[Docket No. FAA-2005-21680; Directorate Identifier 2004-SW-48-AD]

Airworthiness Directives; Bell Helicopter Textron Canada Model 206A, A-1, B, B-1, L, L-1, L-3, L-4 Helicopters

ACTION: Notice of proposed rulemaking (NPRM).

Figure 1

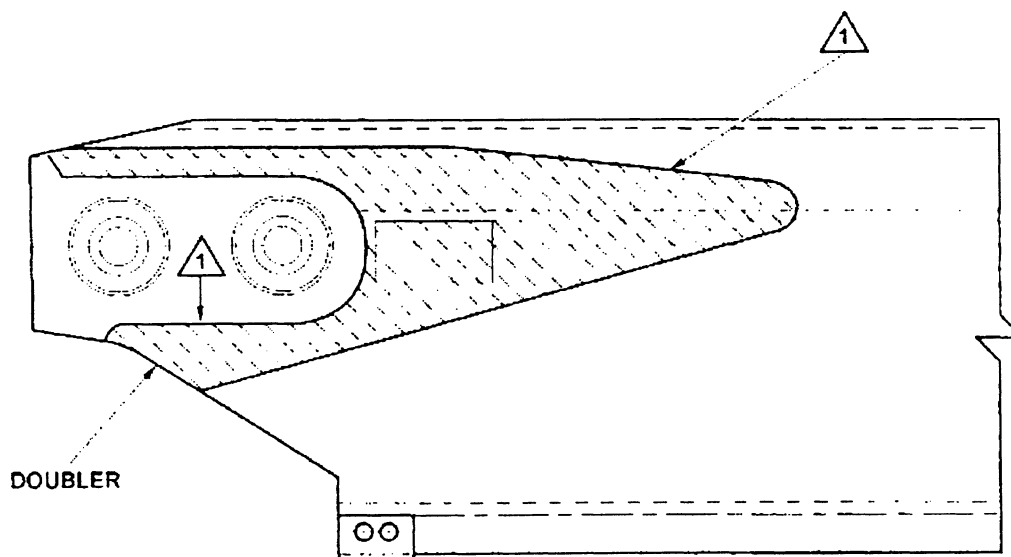
(a) Before the first flight of each day, clean each blade and visually check the blade root doublers for an edge void or de-bond on both sides of each blade as depicted in Figure 1 of this AD. An owner/operator (pilot), holding at least a private pilot certificate, may perform this visual check and must enter compliance with this paragraph into the helicopter maintenance records by following 14 CFR sections 43.11 and 91.417(a)(2)(v).

1 Inspect the doubler for an edge void or de-bond on both sides of each blade.

(b) If an edge void or a de-bond is found, before further flight, replace the blade with an airworthy blade with a serial number other than those to which this AD applies.

(c) Within 100 hours time-in-service, replace all affected, serial-numbered blades with airworthy blades with a serial number other than those to which this AD applies.
